Design Review Commission Report

Meeting Date: Thursday, January 7, 2016
(continued from Thursday, December 3, 2015)

Subject: **341 South Canon Drive**
A request for an R-1 Design Review Permit to allow the construction of a new two-story single-family residence located in the Central Area of the City south of Santa Monica Boulevard. The Commission will also consider adoption of a Categorical Exemption, pursuant to the California Environmental Quality Act.

reference/title: 3-DIMENSIONAL PERSPECTIVE RENDERING

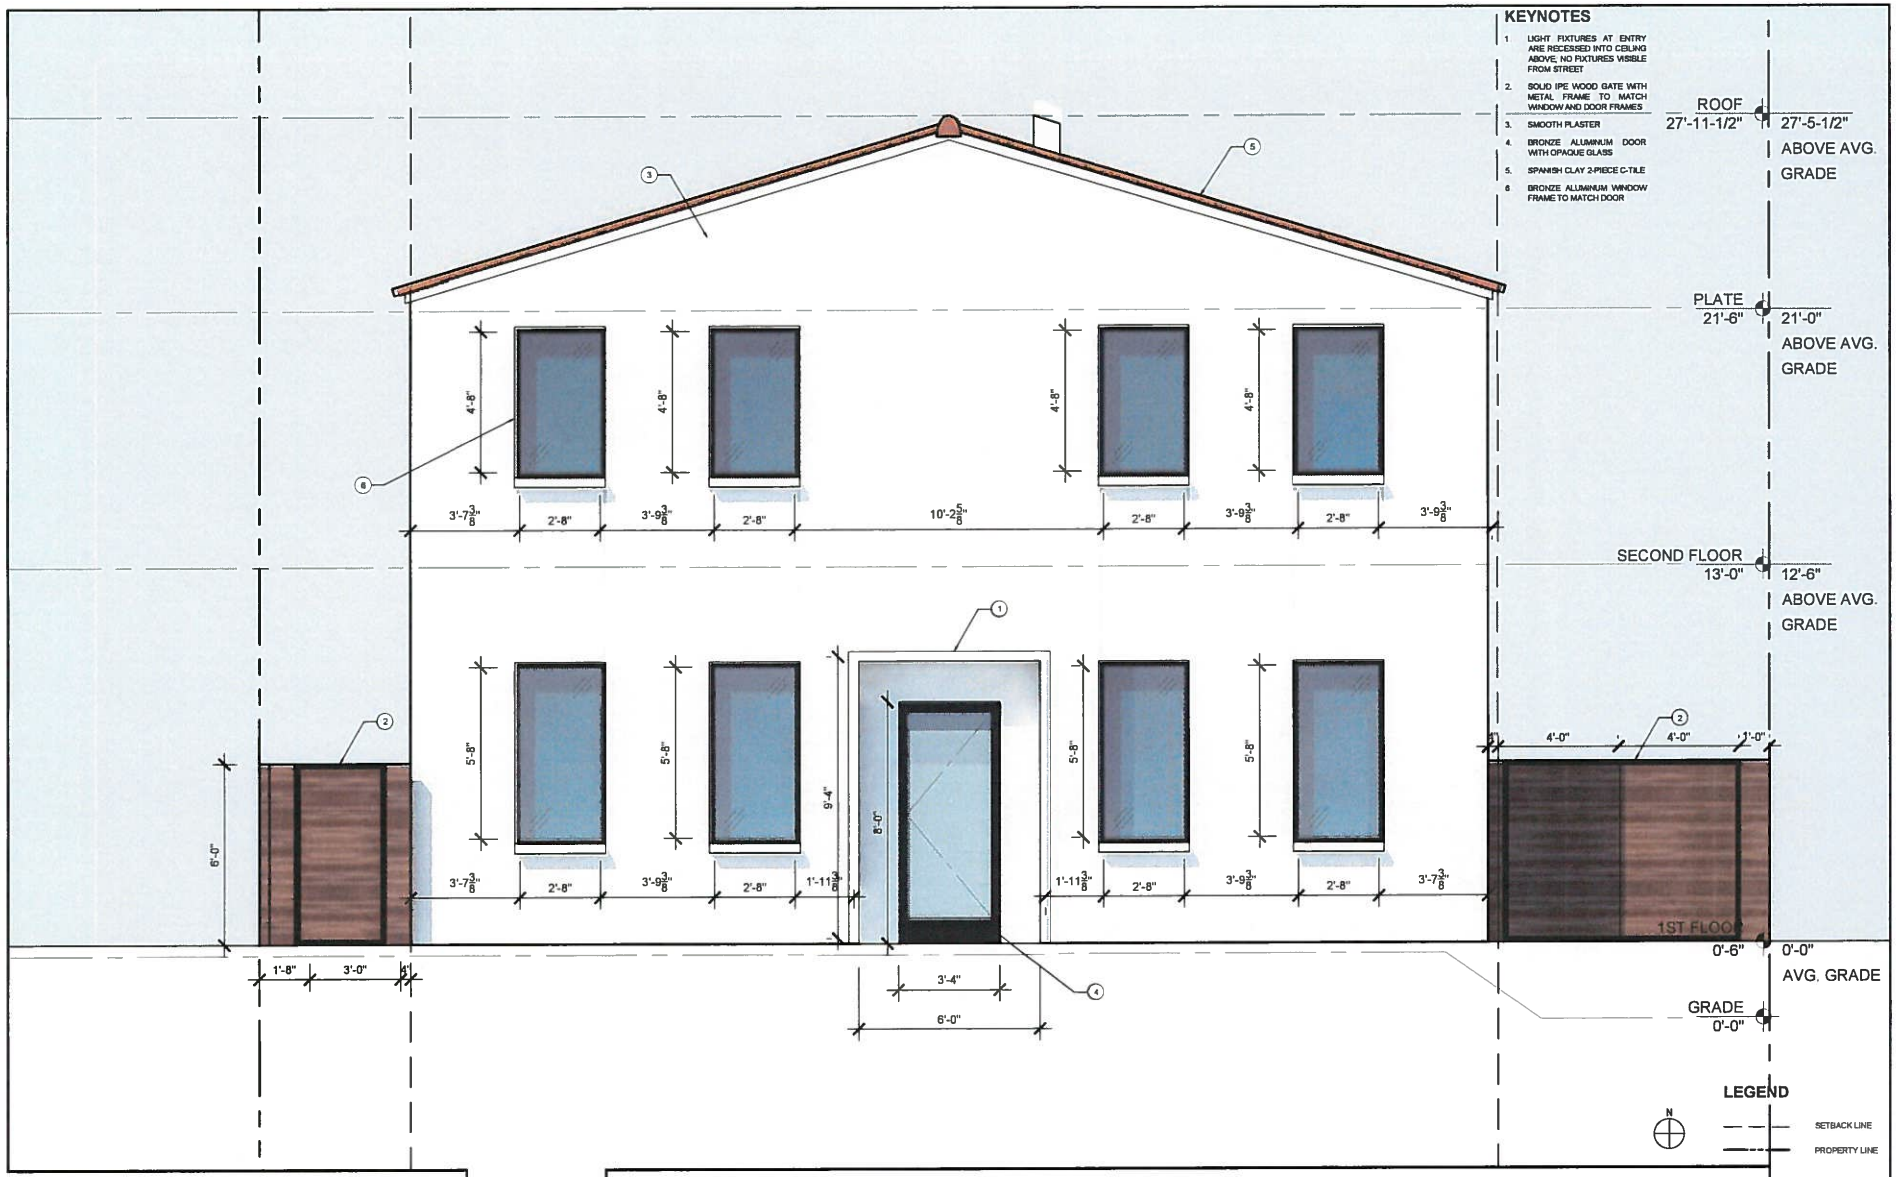
The overall design appears overly simplistic, lacks dimensionality and visual interest, and the boxy form is not articulated with architecturally appropriate modulation. The design could benefit from primary, secondary, and tertiary elements to create a more internally compatible design scheme that would positively enhance the streetscape of South Canon Drive and express a more coherent Mediterranean Modern architectural style.

The applicants own renderings show that the proposed design hardly minimizes the appearance of scale and mass. Indeed this project would have

reference/title: 3-DIMENSIONAL PERSPECTIVE RENDERING

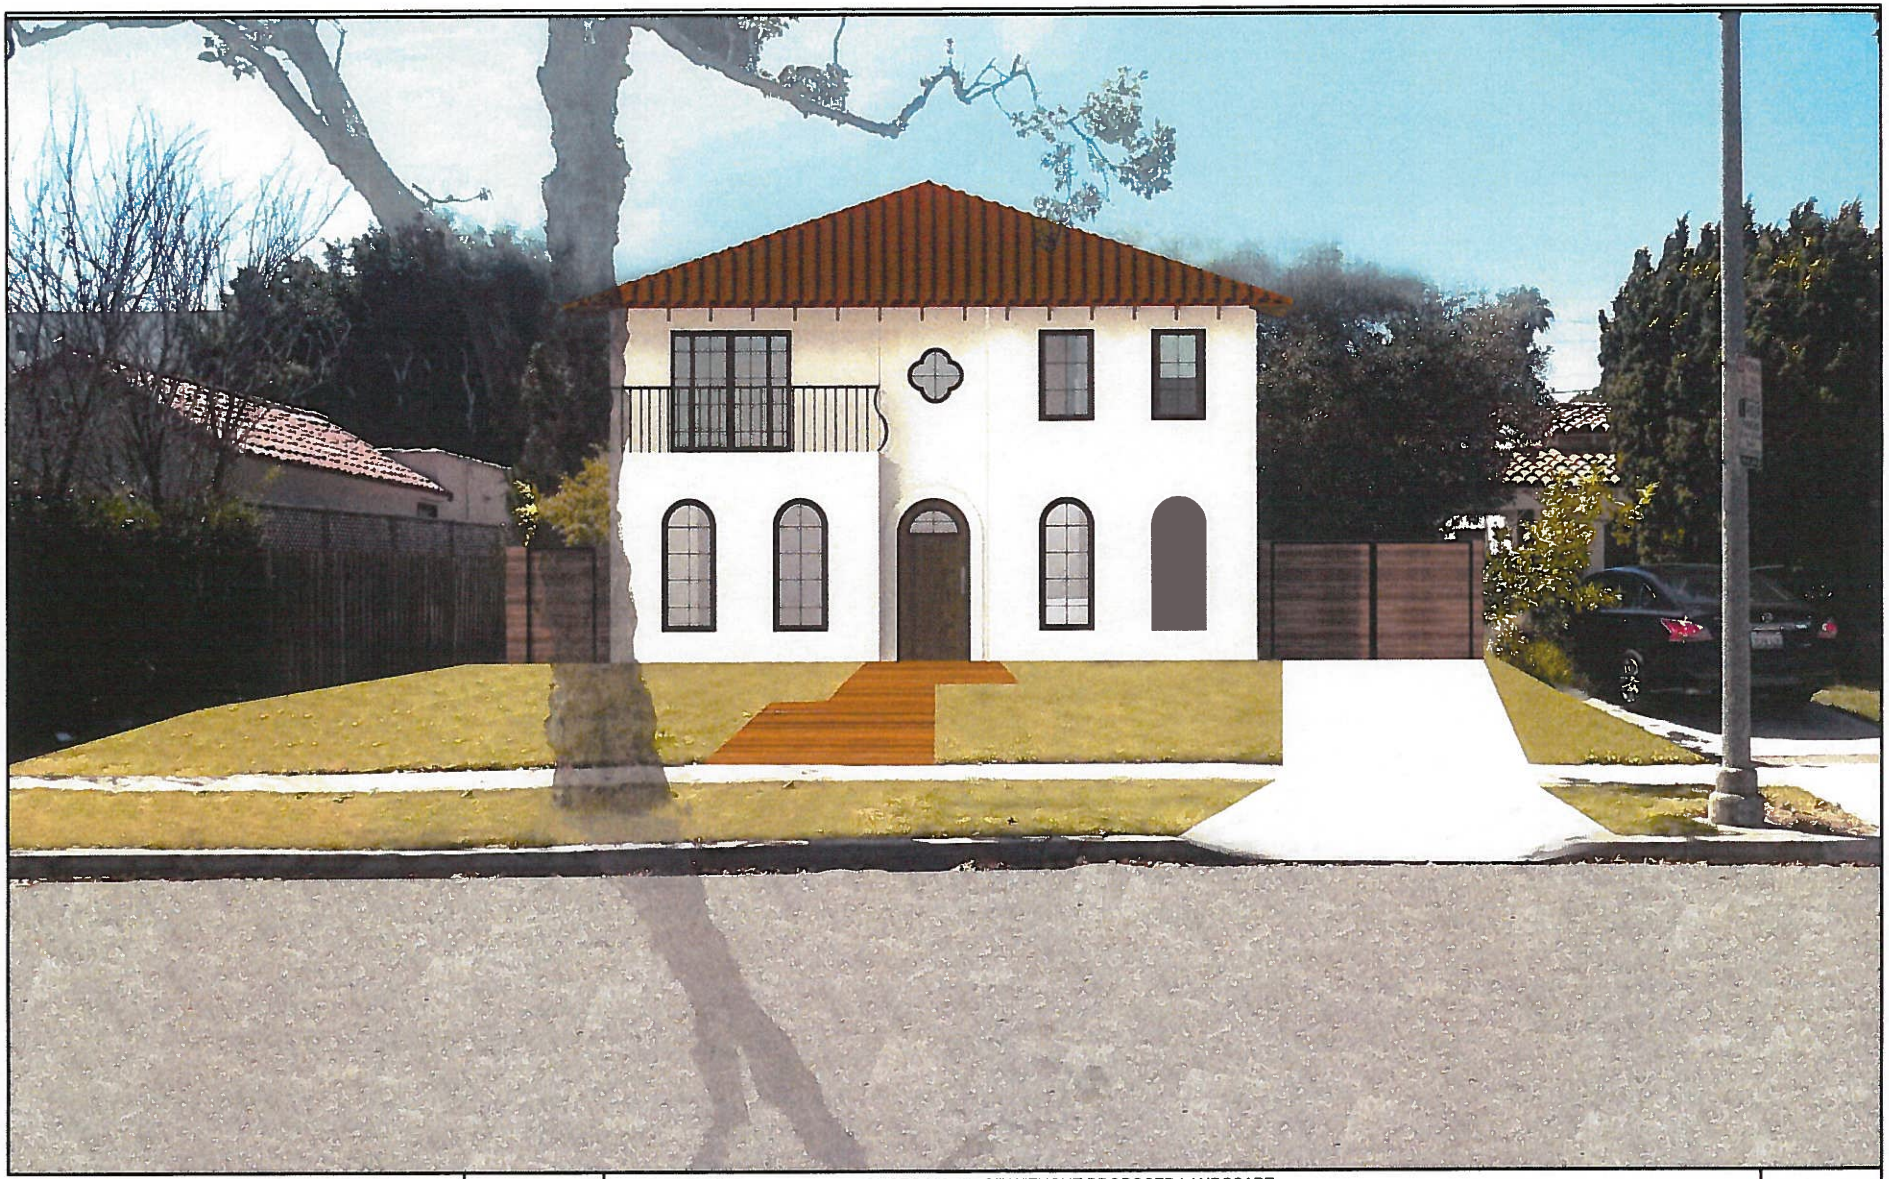
The proposed Mediterranean Villa-styled single-family residence exhibits a more coherent architectural theme; however, the appearance of bulk and mass does not appear to have been mitigated appropriately. Additionally, the project does not contain a hierarchy of architectural elements and may benefit from meaningful modulation and revised proportions that are more consistent with a Mediterranean Villa, which may assist in minimizing the bulk and mass of the single-family residence.

- **"Reduce Bulk and Mass"** – We have articulated the façade by bringing the roof level down to a hip roof, extruding the 1st floor on the left side to create a balcony with an ornamental railing and recessing the center, doorway area, of the façade. We feel this will create a ease of scale transition from our single story neighbors in addition to reducing the bulk and mass of the façade.

- **"Add Detailing"** – We are proposing custom Walnut wood windows and a solid walnut door with a top window. We have also added a decorative center window. All windows are to be recessed 8".

- **"Add a Horizontal Element"** – That is evident in the balcony on the left side of the façade.

- **"Theme Determination"** – We feel we have moved closer to the traditional Mediterranean Villa by rounding the 1st floor windows, adding the aforementioned balcony, detailing the fenestration and articulating the façade.
